# District 7 - Road Safety Assessment Team Findings Summary

SR 60 (Gulf to Bay Boulevard) at CR 501 (S Belcher Road)

Section: 15 040 000 MP: 3.441

**July 2014**

Edge line on north side of west leg Worn edge line markings Refurbish the pavement markings

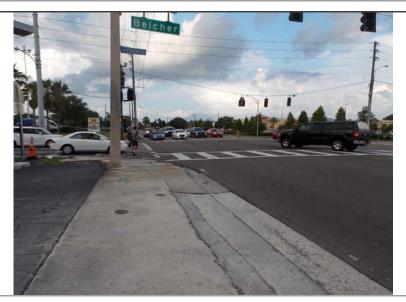
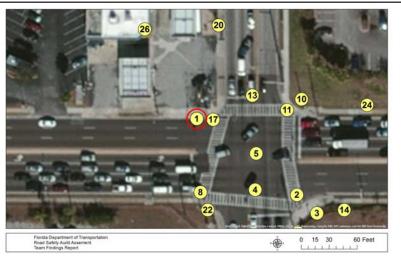
The edge line along the westbound leg on the northwest quadrant is worn.

Refurbish the section of worn pavement markings.

Maintenance office will address.

Southeast quadrant Pedestrian indication rotated Align with crosswalk

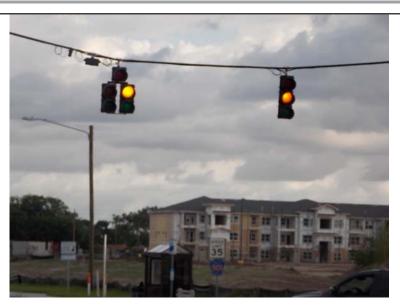
The pedestrian signal indication located in the southeast quadrant of the intersection is not properly aligned with the south leg crosswalk. It appears that either the post was knocked off center during a collision, or that the pedestrian indication was not re- aligned concurrent with the installation of the eastbound right-turn lane, which shifted the sidewalk to the south along the southwest quadrant.

Re-align the pedestrian indications with the crosswalk on the south leg of the intersection for the west to east pedestrian crossing.

FDOT will coordinate the improvement with the City of Clearwater.

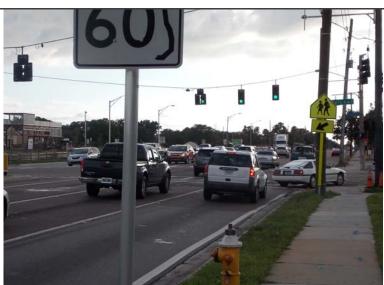
The team observed that there are no turn restriction signs at the right-in / right-out driveway for Publix along Belcher Road south of Gulf to Bay Boulevard.

Provide right-turn only signs.

Pinellas County will coordinate with the City of Clearwater.

10 Northeast quadrant

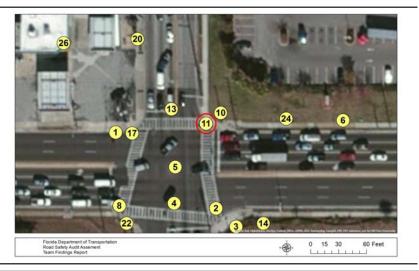
Pedestrians and bicyclist were observed pushing both push buttons when waiting to cross either Gulf to Bay Boulevard or Belcher Road. Some pedestrians indicated that due to the proximity of the buttons, they do not know which button to push.

In the short term, separate the bush buttons and signs on the existing signal pole. Concurrent with the signal rebuild, replace the single push button instruction sign with separate buttons and signs denoting the name of the intersection that each button controls respectively. Also consider installing feedback push buttons to reassure that buttons have been activated.

FDOT will coordinate with the City of Clearwater.

12 Intersection approaches

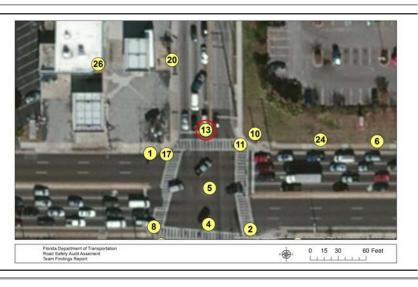
An advanced intersection sign for Belcher Road exists heading westbound. However, similar signs are not present heading eastbound, northbound, or southbound approaching this intersection.

Provide advance street name signs for all approaches.

FDOT will coordinate sign installations with Pinellas County Traffic.

Southeast quadrant

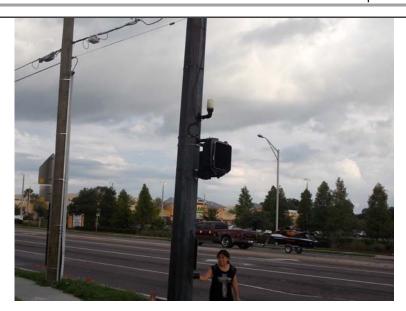
The police officers indicated that the limited right-of-way and curbs make it challenging to do safe red light running enforcement at this intersection; there is nowhere to safely park. There are incandescent enforcement lights mounted near the pedestrian signal heads on the signal poles.

Upgrade the enforcement lights to white LED to improve visibility.

FDOT will coordinate with City of Clearwater.

Sidewalk on west side of Belcher on north leg of the intersection

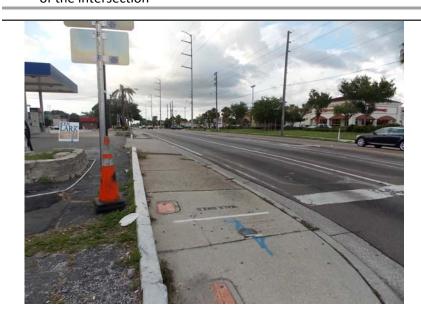
The sidewalk along the west side of the north leg of the intersection does not appear to be up to ADA standards. The truncated dome pads along the sidewalk at driveways along the segment denote that the intersection of the sidewalk with the driveway is dominated by the driveway; that it is intended for vehicles. A preferable configuration has the sidewalk extending through the driveway.

This segment on Belcher Road to the north of Gulf to Bay Boulevard should be upgraded to meet current ADA standards; particular the cross slopes and surface texture at the driveways. Bring the sidewalk up to grade (this will either require an easement to re-align the sidewalk or to re-profile the sidewalk) and remove the truncated dome pads at the driveways; it should appear as if the sidewalk traverses through the driveway denoting that pedestrians are intended to walk there. The water main access on the sidewalk needs to be addressed.

Pinellas County will coordinate with the City of Clearwater for improvements.

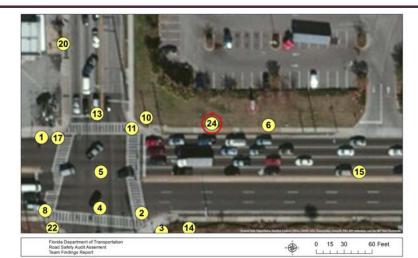
Although westbound right-turn volumes exceed 100 vehicles per hour during peak travel periods, there is no westbound right-turn lane at this intersection. Right-turning vehicles turning out of the shared thru-right lane may turn at greater speeds out of concern for rear-end crash conflicts and therefore be less able to yield to pedestrians crossing the north leg of the intersection. Drivers following too closely to right-turning vehicles may cause rear-end crashes—especially if a driver stops short to yield to a pedestrian and/or may cause sideswipe crashes if they change lanes unexpectedly to avoid leading vehicles that are slowing to turn.

Based on visual inspection of the area, it appears feasible to construct a west-bound right turn lane approximately 200ft in length (including taper). During higher-volume periods of the day, traffic will be blocked from entering this lane by the thru queues limiting the capacity benefit; however, the lane will provide a space for turning vehicles to safely decelerate before turning onto northbound Belcher Road which is the primary purpose of the lane from a safety perspective. As noted in the Observations above, the ability to decelerate to a safe turning speed without concern of being rear-ended by thru traffic will help right-turning drivers to be more conscious of pedestrians crossing Belcher. Installation of R10-15 (right turn yield to pedestrian) signs and or staggered stop bar will help to reinforce this behavior.

Concerns related to providing a right turn lane include: costs associated with right-of-way acquisition and utility re-location, the need to introduce a skew into the crosswalk across Belcher Road (north leg of the intersection) and increasing the number of lanes that must be crossed by a pedestrian crossing Gulf-to-Bay (east leg of the intersection). If deemed cost-feasible by a detailed engineering analysis, the benefits to reduce rear-end, sideswipe, and right-turn-on-green pedestrian conflicts on-balance suggest a net safety benefit.

FDOT will evaluate the feasibility with the upcoming resurfacing project.

25 Southwest Quadrant

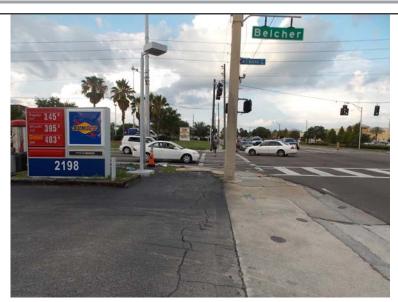
The southwest quadrant is under construction.

Conduct post analysis for additional traffic at Gulf to Bay Boulevard and Belcher Road intersection as redevelopment completes.

FDOT will coordinate improvement with the City of Clearwater.
